Well Name: BIG EDDY UNIT DI BB

Notice of Intent

Procedure Description: **Surface Location Move, Casing/Cement, Drilling Variance Changes XTO Permian Operating, LLC requests permission to make the following changes to the original APD: No Additional Surface Disturbance Change SHL fr/470'FSL & 640'FWL to 490'FSL & 640'FWL. Well Stays in the Same Quarter-Quarter as Permitted Total SHL Move: 20'North SHL change requested to optimize well pad layout, drilling efficiencies, and for safety purposes. Casing/Cement design per the attached drilling program. Attachments: C102 Drilling Program Directional Plan Multibowl Diagram

DRILLING PLAN: BLM COMPLIANCE (Supplement to BLM 3160-3)

13-3/8" x 9-5/8" x 5-1/2" 10M RSH-2 Wellhead Assembly, With T-EBS-F Tubing Head

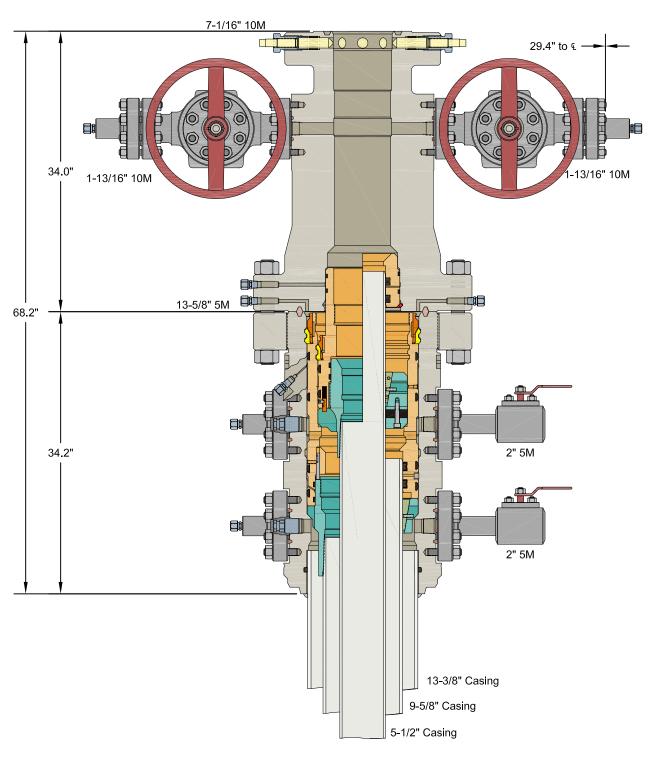
Permanent Wellhead - Multibowl System

A. Starting Head: 13-5/8" 10M top flange x 18-5/8" bottom

- B. Tubing Head: 13-5/8" 10M bottom flange x 7-1/16" 15M top flange
 - Wellhead will be installed by manufacturer's representatives.
 - Manufacturer will monitor welding process to ensure appropriate temperature of seal.
 - · Operator will test the 9-5/8" casing per BLM Onshore Order 2

- a. Wellhead shall be installed by manufacturer's representatives, submit documentation with subsequent sundry.
 - b. If the welding is performed by a third party, the manufacturer's representative shall monitor the temperature to verify that it does not exceed the maximum temperature of the seal.

Note: Picture below highlights BOP components that will be tested during batch operations

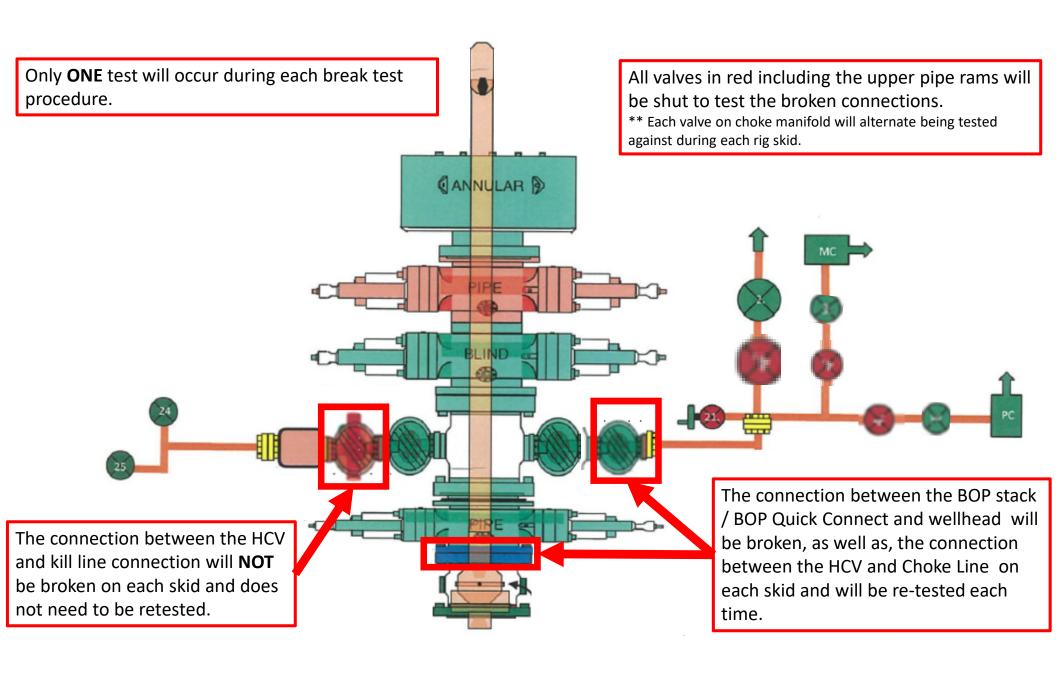
XTO Energy requests a variance to ONLY test broken pressure seals on the BOPE and function test BOP when skidding a drilling rig between multiple wells on a pad.

- 3. After performing a complete BOP test on the first well, the intermediate hole section will be drilled and cased, two breaks would be made on the BOP equipment.

- a. Between the HCV valve and choke line connection
 - b. Between the BOP guick connect and the wellhead
- 4. The BOP is then lifted and removed from the wellhead by a hydraulic system.

- 5. After skidding to the next well, the BOP is moved to the wellhead by the same hydraulic system and installed.
- 6. The connections mentioned in 3a and 3b will then be reconnected.

- 7. Install test plug into the wellhead using test joint or drill pipe.
- 8. A shell test is performed against the upper pipe rams testing the two breaks.

- 9. The shell test will consist of a 250 psi low test and a high test to the value submitted in the APD or Sundry (e.g. 5,000 psi or 10,000psi).
- 10. Function test will be performed on the following components: lower pipe rams, blind rams, and annular.

- 1. After a full BOP test is conducted on the first well on the pad.
- 2. The first intermediate hole section drilled on the pad will be the deepest. All of the remaining hole sections will be the same depth or shallower.
- 3. Full BOP test will be required if the intermediate hole section being drilled has a MASP over 5M.
- 4. Full BOP test will be required prior to drilling the production hole.

Wellhead diagram during offline cementing operations

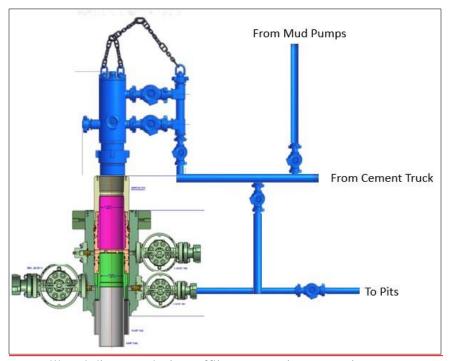
- 10. Circulate bottoms up with cement truck
 - a. If gas is present on bottoms up, well will be shut in and returns rerouted through gas buster to handle entrained gas
 - b. Max anticipated time before circulating with cement truck is 6 hrs
- 11. Perform cement job taking returns from the annulus wellhead valve
- 12. Confirm well is static and floats are holding after cement job
- 13. Remove cement equipment, offline cement tools and install night cap with pressure gauge for monitoring.
